SUBJECT: COMANCHE PEAK STEAM ELECTRIC STATION
DOCKET NOS. 50-445 and 50-446
CONTAINMENT SUMP PERFORMANCE

TEXAS UTILITIES GENERATING COMPANY
COMANCHE PEAK STEAM ELECTRIC STATION
Containment Paint Evaluation -
Reply to NRC Questions

CONTAINMENT PAINT EVALUATION - REPLY TO NRC QUESTIONS

FIGURE 1

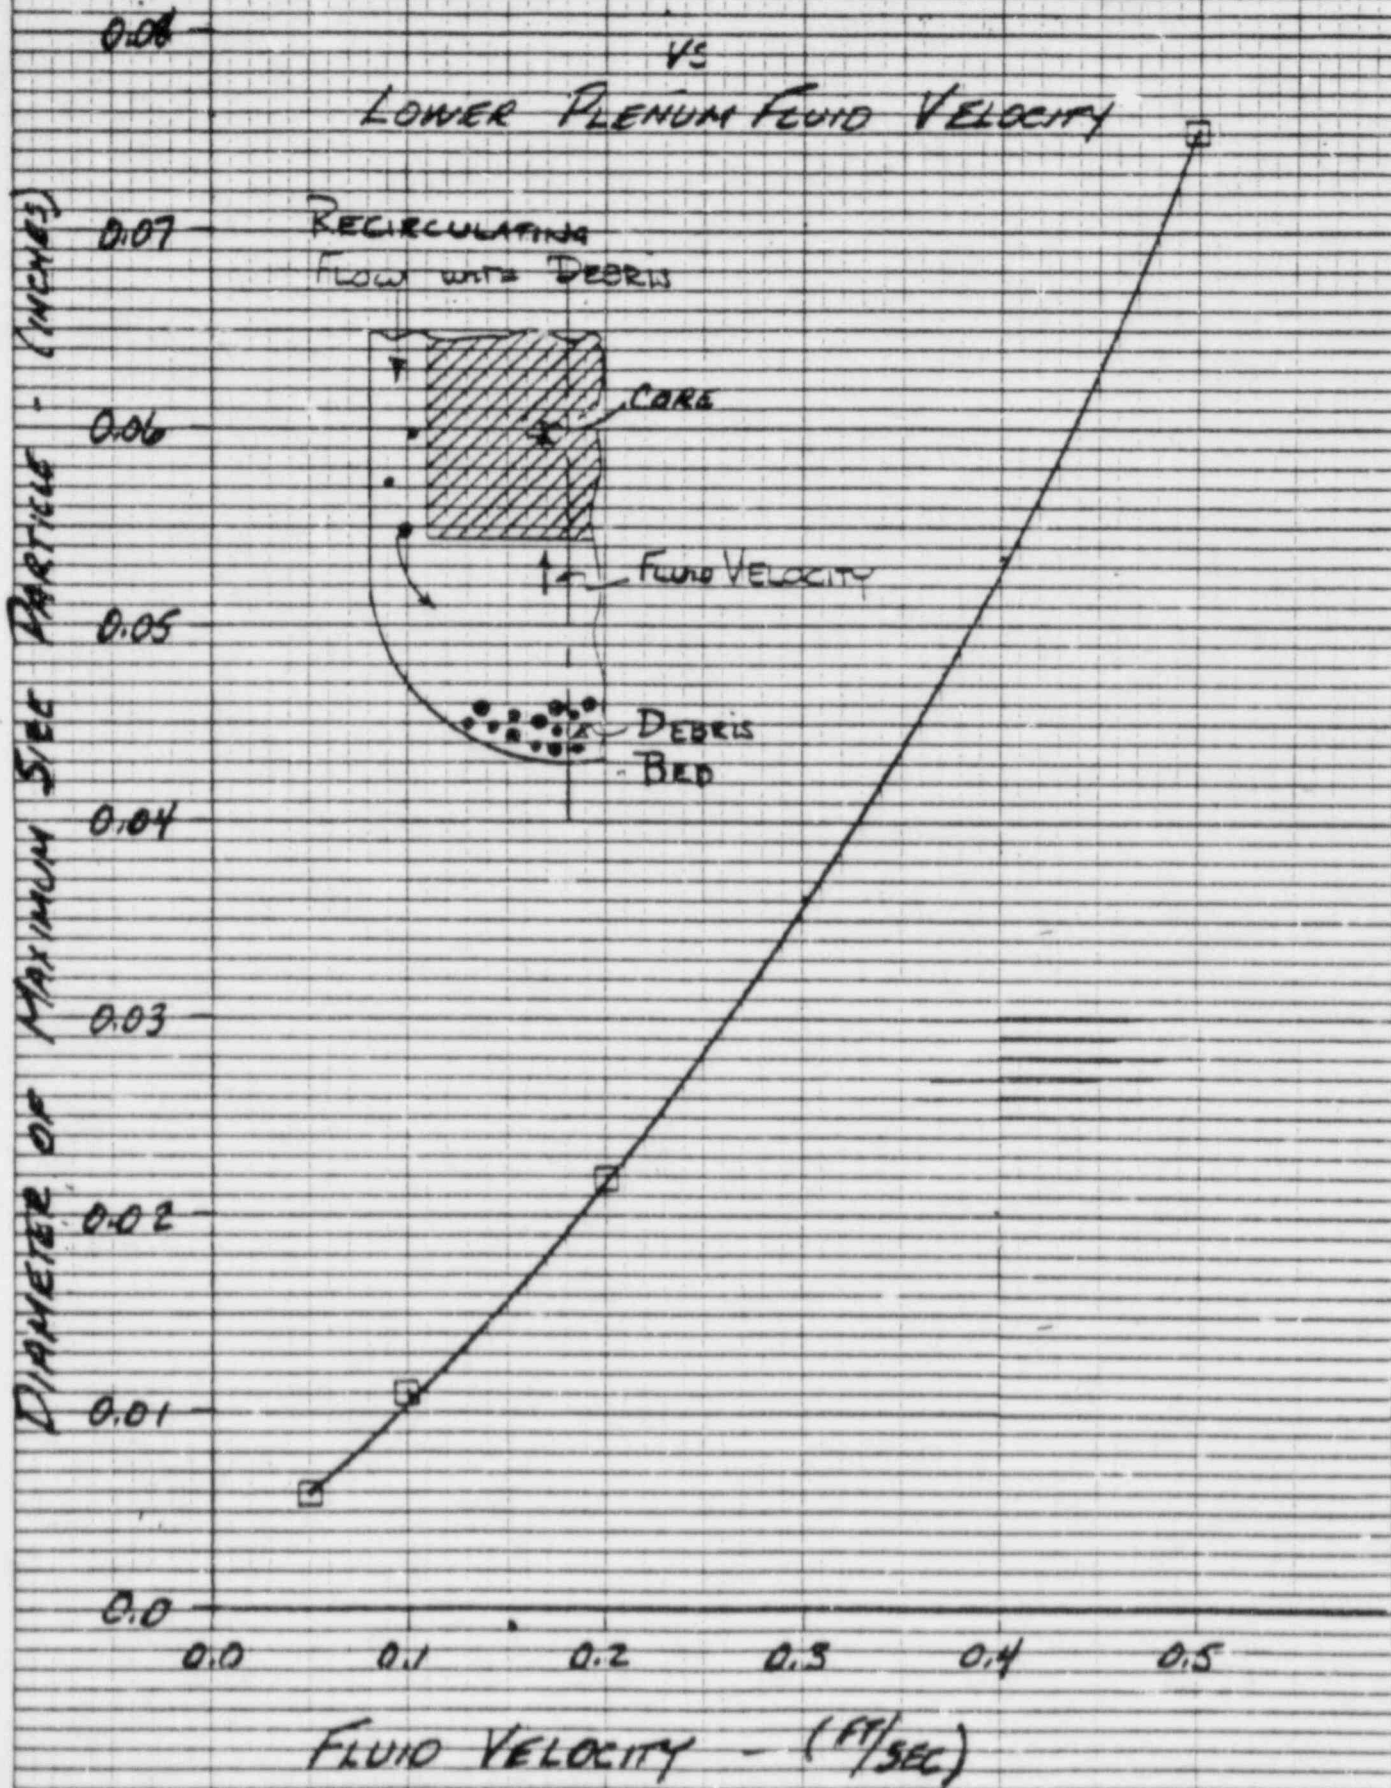
- 1) What is the basis for concluding that paint fines will settle out in the Reactor Vessel?

3) What is the impact of paint fines on the core?

Using the preceding assumptions and performing a force balance that accounts for drag, gravity, and hydrostatic forces, a relationship identifying the maximum debris particle size that can be carried by a vertically flowing fluid with a given velocity was developed. A plot of that relationship is given in Figure 1.

The vertical velocity of the recirculating fluid in the lower plenum prior to its passing through the core support plate will determine the maximum debris size that can be carried into the core. A typical fluid velocity in the core during cold leg recirculation following a cold leg break is 0.1 ft/sec. Using the core velocity to evaluate a conservatively large debris particle size, the data of Figure 1 indicates that the maximum size of debris passing through the core will be about 0.011 inches in diameter.

Thus for two RHR pumps operating, the fluid velocity in the RV/core barrel annulus is sufficient to reentrain debris that may cause core blockage if it is reintroduced to the RV. From Figure 1, it is concluded that if the fluid velocity in the lower plenum is less than 0.33 ft/sec, only debris that is less than 0.040 inches in size may be entrained. Typically, the fluid velocity in the lower plenum is a maximum where the fluid turns to flow up the downcomer. Figure 3 shows the relationship between vessel flow rate, debris bed height, and fluid velocity as it turns into the downcomer from the lower plenum. From Figure 3, the velocity of the turning fluid is predicted to be below 0.30 ft/sec for debris beds less than 4.7 feet in height. From Figure 4, which is a plot of vessel volume versus vessel height, the debris bed
